Access Compliance Report

Public Rights-of-Way

(Pedestrian Signals)

Intersection ID: N/A	Main Street:	Cross Street: N/A	Location: N/A
ADA ID: 6289473FB42E	Signal Type: One Push Button-APS	Overall Compliance: No	Severity Score: BTN 1: N/A BTN 2: N/A No BTN: N/A
Codes/Mitigation Info/Possible Solution		Field Measurements/Component Compliance

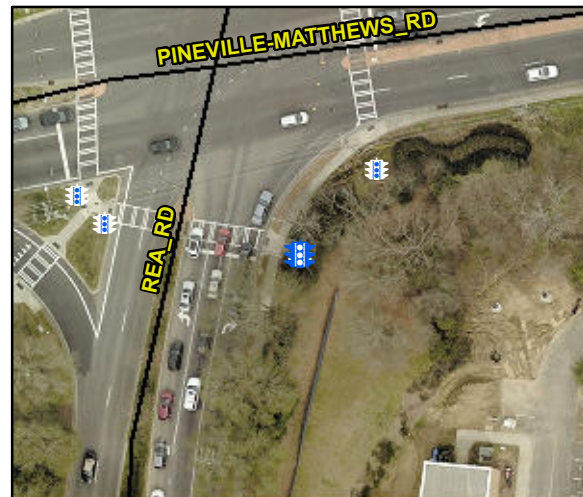
Possible Solutions: Replace Signal Push Button With APS Button on New Post. Remove & Relocate Sign.

Yes	B 1 Clear Xing Direction?	ClearlyMarked	N/A	B 2 Clear Xing Direction?	N/A
	B 1 Crossing Direction	To W		B 2 Crossing Direction	N/A
Yes	B 1 DistanceTo XWalk (in)	0.0	N/A	B 2 DistanceTo XWalk (in)	N/A
No	B 1 DistanceTo Curb (in)	136.0	N/A	B 2 DistanceTo Curb (in)	N/A
Yes	B 1 Diameter (in)	2.0	N/A	B 2 Diameter (in)	N/A
